Product Advisory (PA)

Subject: Addition of an inner box for taped packaging products of photocouplers

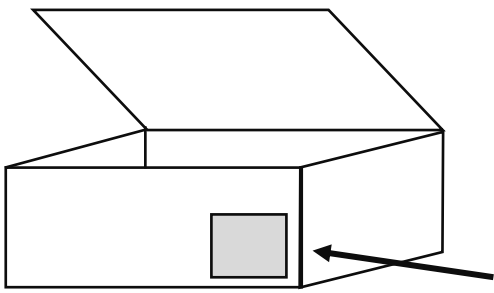
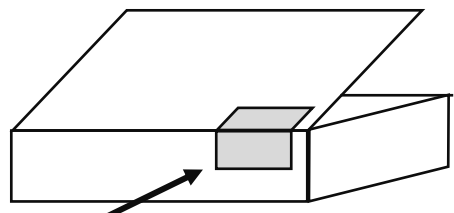
Renesas will add an inner box for taped packaging products of photocouplers.

Current	Addition
Dimensions(mm)	335 × 335 × 95	347 × 368 × 63
Label placement	Bottom right of the box-opening side 	Upper right of the side opposite the box-opening side
